PRELIMINARY PLAN
WILGUS TRACT
120200140

RE: Preliminary Plan and Design Exceptions
Preliminary Plan No. 120200140
Wilgus

We have completed our review of the revised preliminary plan uploaded to eplans on April 21, 2020. A previous version of this plan was reviewed by the Development Review Committee (DRC) at its meeting on March 17, 2020. We recommend approval of the plan subject to the following comments:

Cherington Review of Wilgus Preliminary Plan Submission, March 12, 2020

PROPOSED STREET SECTIONS

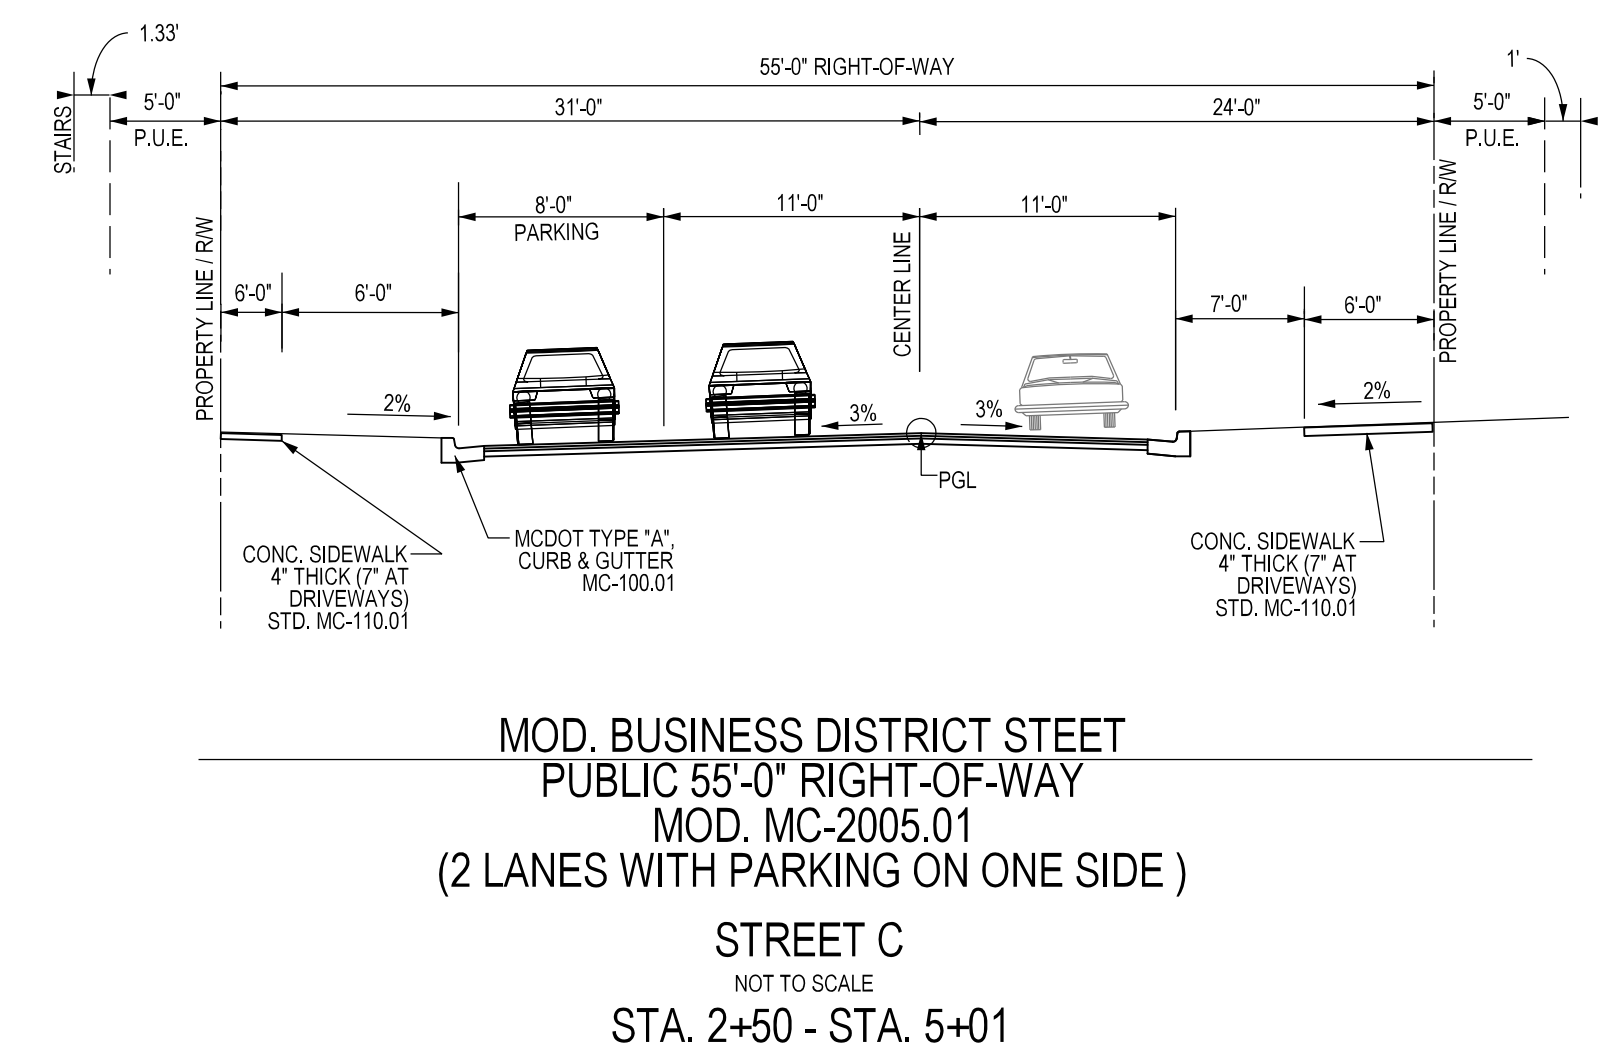
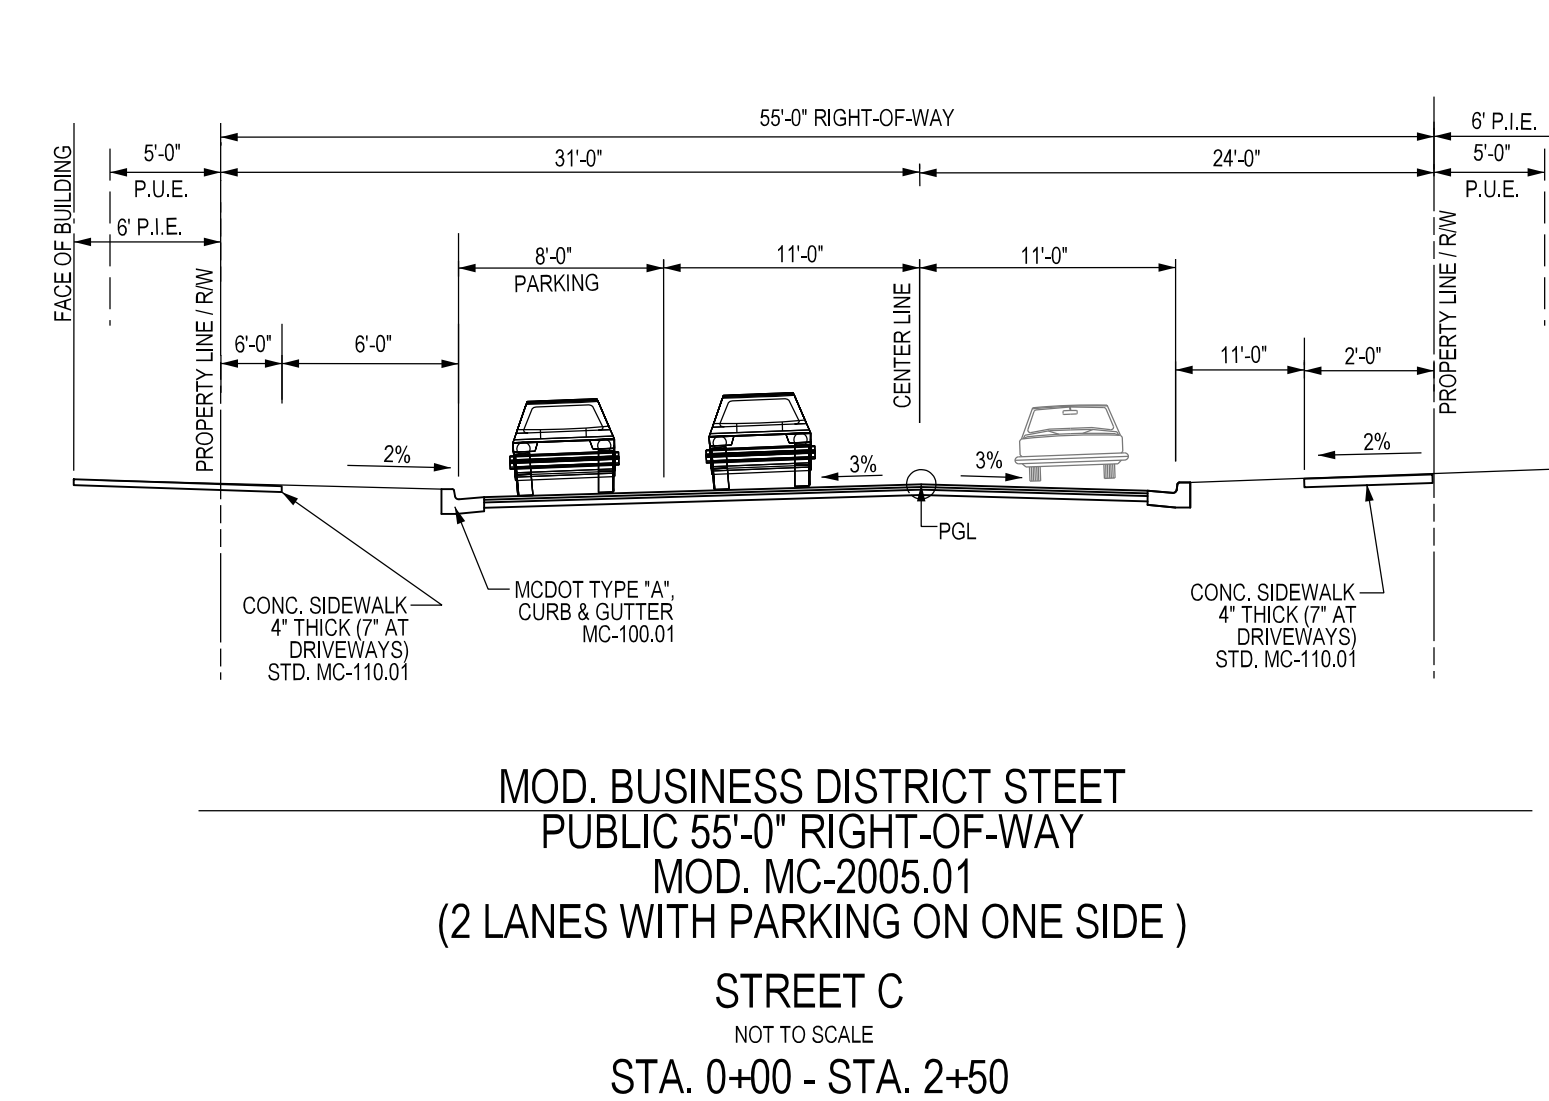
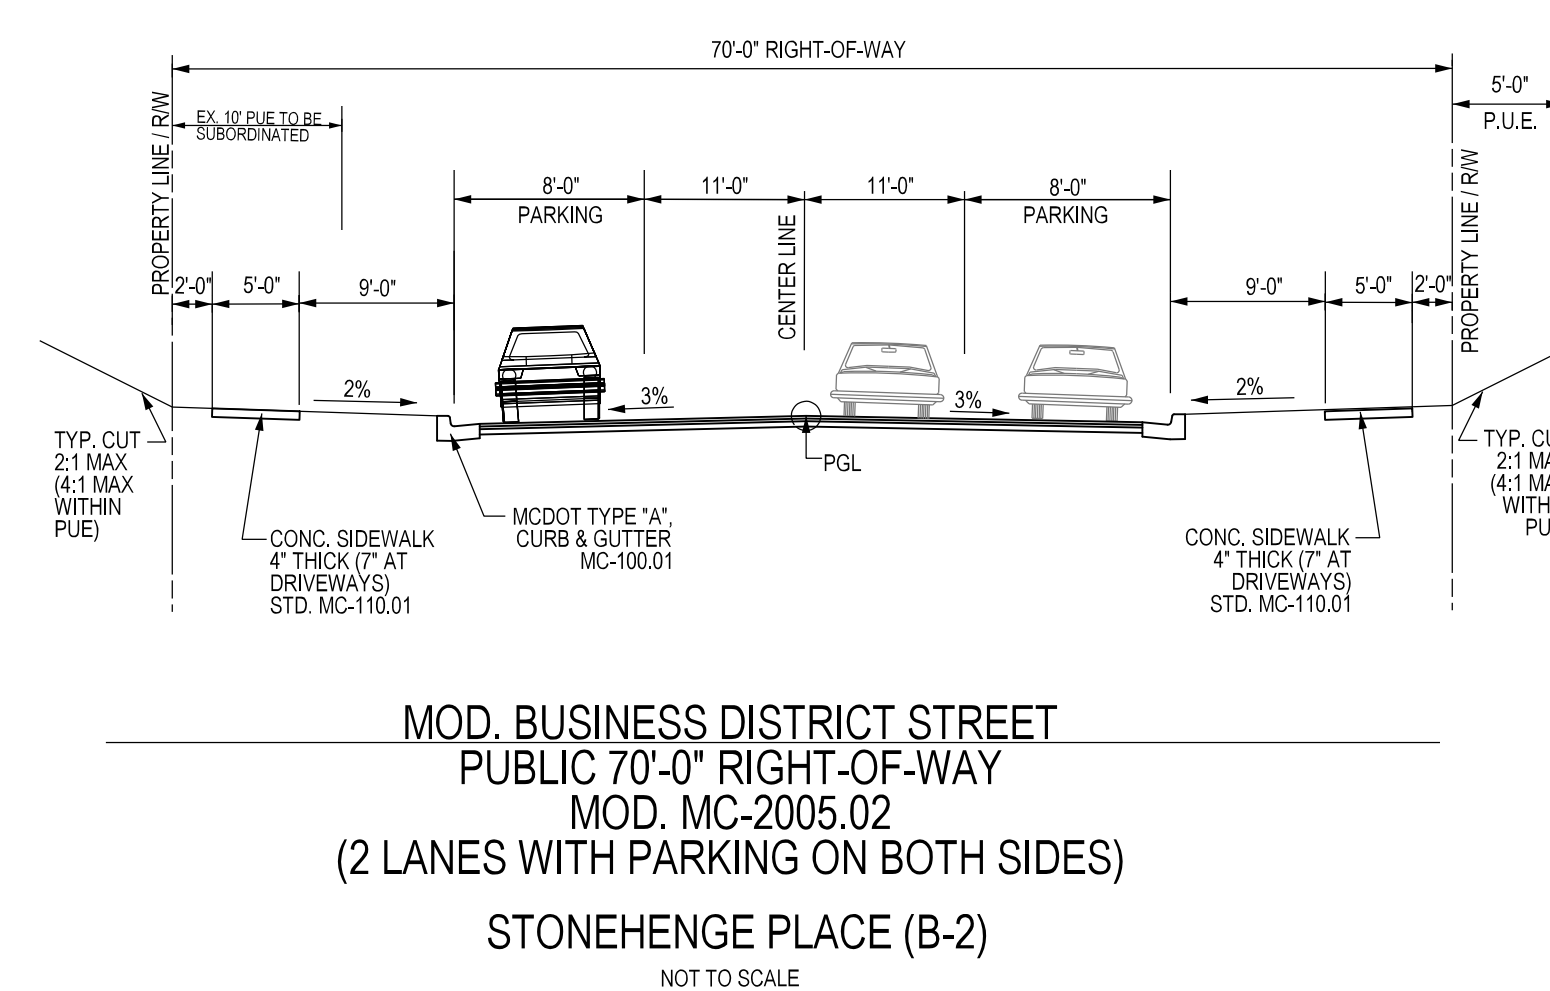
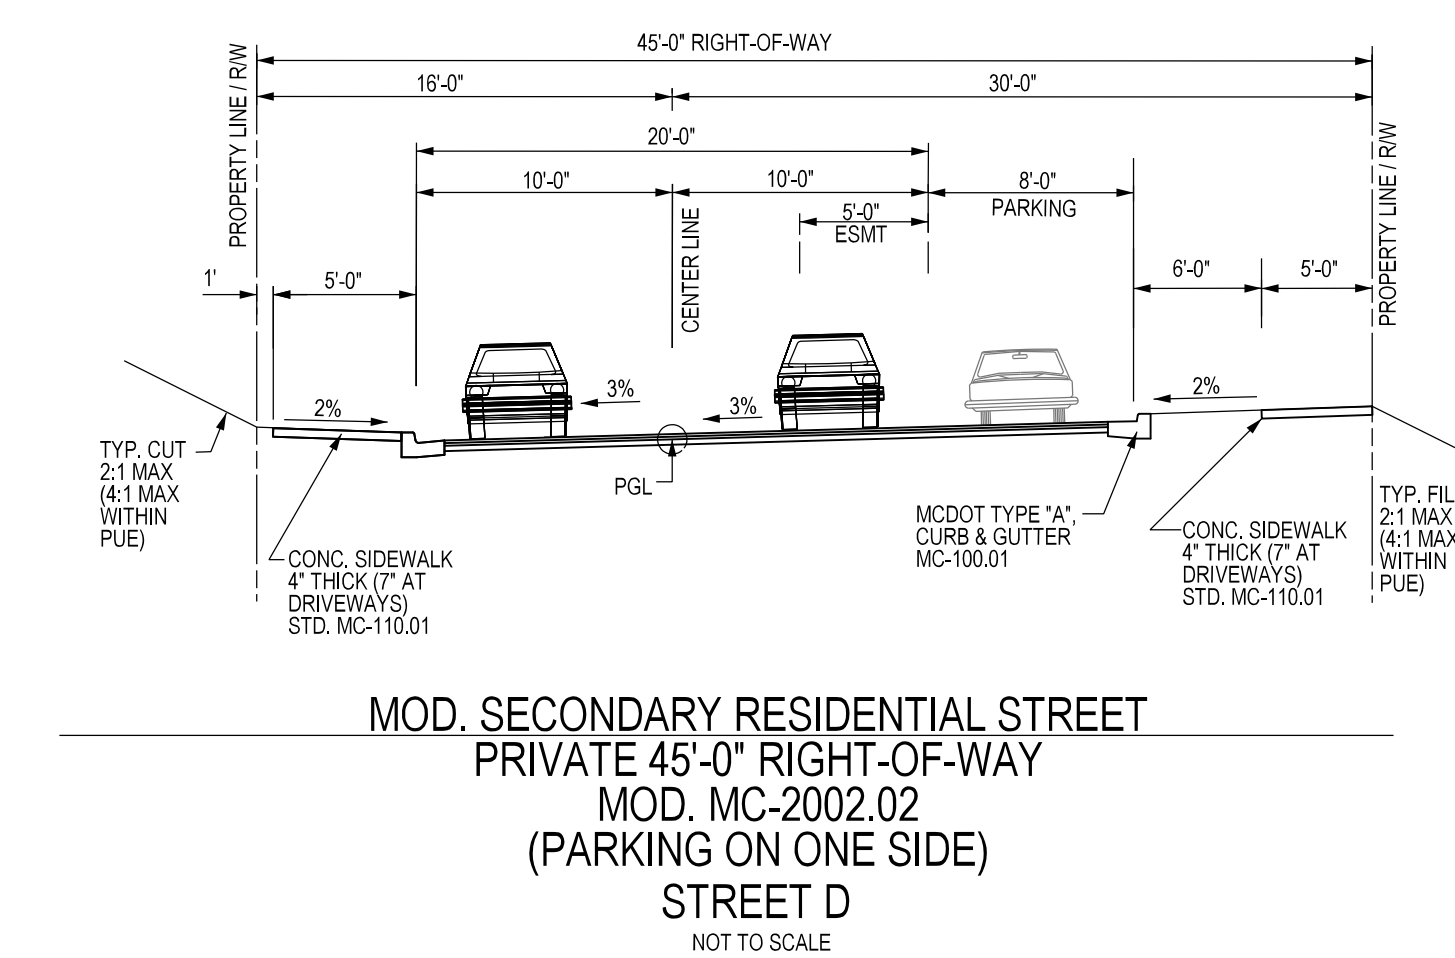
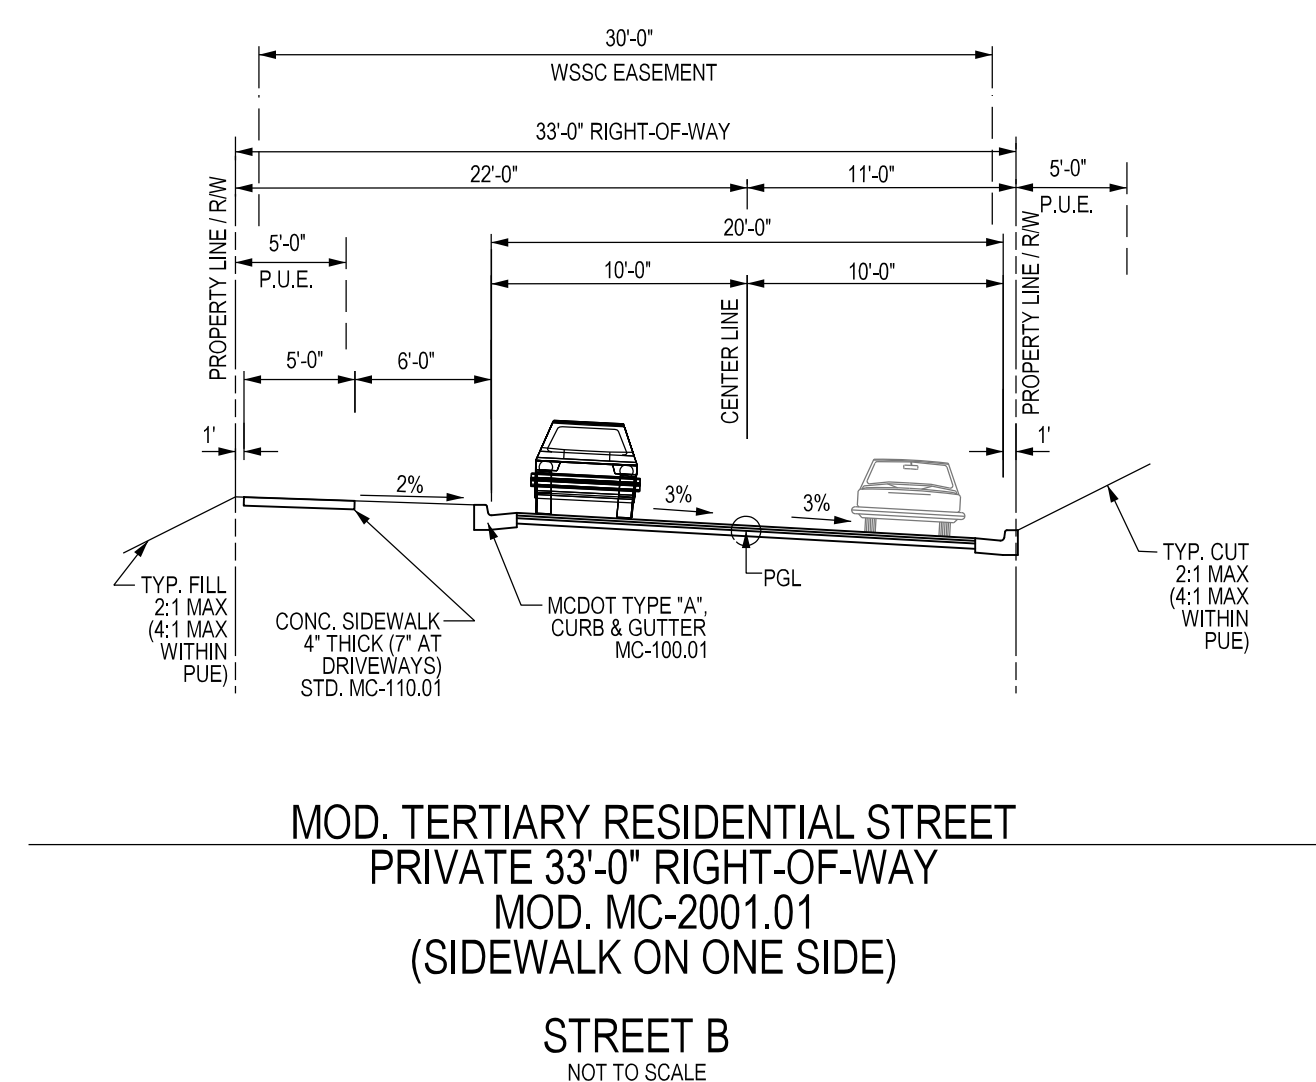
1. A-1 - Modification of Context Sensitive Road Section – Stonehenge Place (B-2): The applicant is proposing to modify MCDOT Standard No. MC-2005.02, maintaining the full 70-foot right-of-way, but reducing the sidewalk and increasing the tree panel. The applicant is proposing the following street section:
 - 2-foot maintenance strip
 - 5-foot sidewalk
 - 9-foot stormwater management/tree panel
 - 8-foot parking section
 - two 11-foot travel lanes
 - 8-foot parking section
 - 9-foot stormwater management/tree panel
 - 5-foot sidewalk
 - 2-foot maintenance strip

2. A-2 - Modification of Context Sensitive Road Section-Public Street C (Station 0+00 to Station 2+50):
The applicant is proposing to modify MCDOT Standard No. MC-2005.01 from a 60-foot to a 55-foot right-of-way by placing some sidewalk outside the right-of-way in a P.I.E., eliminating the 1.5-foot curb offset but increasing the tree panel. The applicant is proposing the following street section:

3. A-3 - Modification of Context Sensitive Road Section-Public Street C (Station 2+50 to Station 5+01):
The applicant is proposing to modify MCDOT Standard No. MC-2005.01 from a 60-foot to a 55-foot right-of-way by moving the outside edges of the sidewalks to the right-of-way line, providing a P.I.E. for sidewalk maintenance, eliminating the 1.5-foot curb offset but increasing the tree panel. The applicant is proposing the following street section:

MCDOT Response: MCDOT **approves** this Design Exception. The proposed road is shown in the master plan, and the applicant is meeting the urban road code standards. The applicant's proposed section will provide more space for stormwater management treatment while maintaining walkability and meeting minimum ADA standards.

MCDOT Response: MCDOT **approves** this Design Exception. The proposed street is not shown in the master plan, and the applicant is meeting the urban road code standards. The applicant's proposed section will provide more space for stormwater management treatment while maintaining walkability and meeting minimum ADA standards.

MCDOT Response: MCDOT **approves** this Design Exception. The proposed street is not shown in the master plan, and the applicant is meeting the urban road code standards. The applicant's proposed section will provide more space for stormwater management treatment while maintaining walkability and meeting minimum ADA standards.
